Nebraska Capitol Environs Commission
Agenda

Agenda of June 26, 2008

to: **Nebraska Capitol Environs Commission**
from: Ed Zimmer
re: Agenda of June 26, 2008
date: June 20, 2008

KAPLAN UNIVERSITY
LINCOLN CAMPUS EXPANSION
1821 K STREET
LINCOLN, NEBRASKA 68508
EXTERIOR ELEVATIONS

A2-1

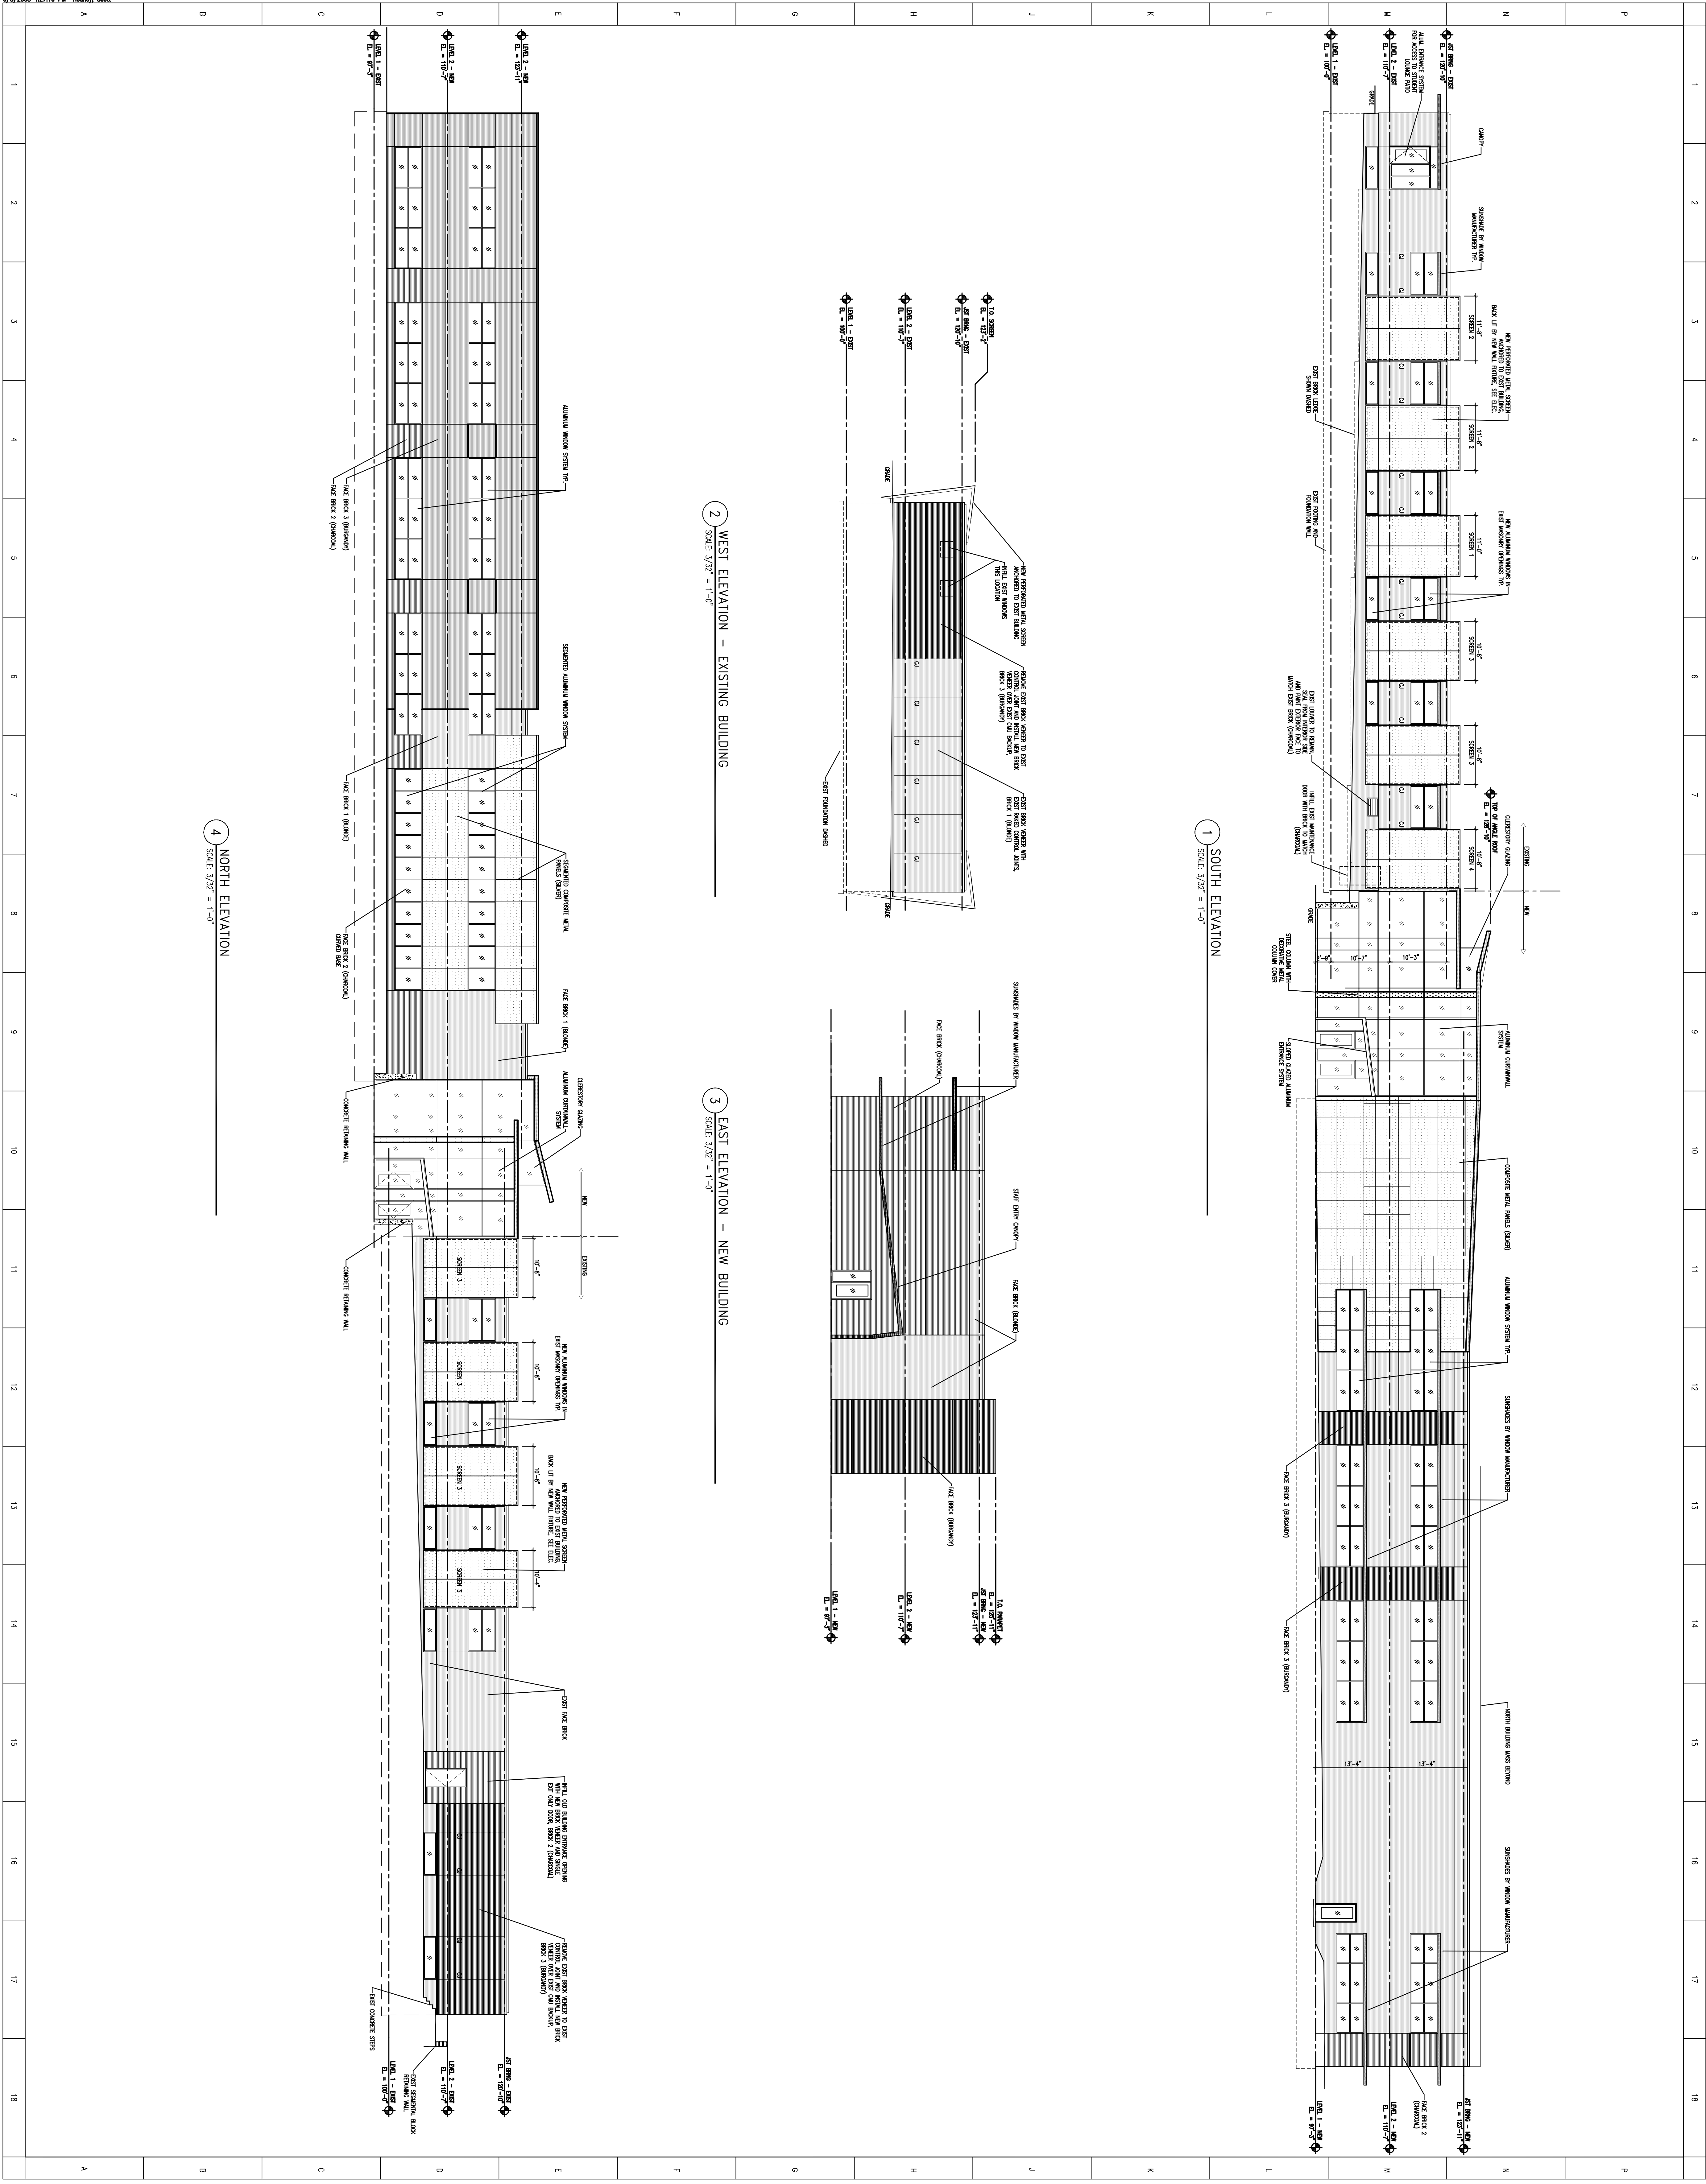
- d) East expansion of the Kaplan building.
This prominent building on K Street qualifies for the Commission’s stated policy of reviewing major projects in concept one month, then taking action at a second monthly meeting.

The project includes a glass curtain-wall link between the existing building and a major addition to the east. The existing building would be modified with the addition of four “perforated metal screen...backlit by new wall fixture”. Materials of the new building include blonde face brick with charcoal brick near the base, silver-colored composite metal panels on a curved feature, and aluminum window systems.

I have added underscoring for emphasis to the standard perhaps most applicable to the project.

As a whole, the Kaplan project appears to offer a significant investment in and improvement to one of the most prominent properties near the Capitol on the east leg of the Environs District.
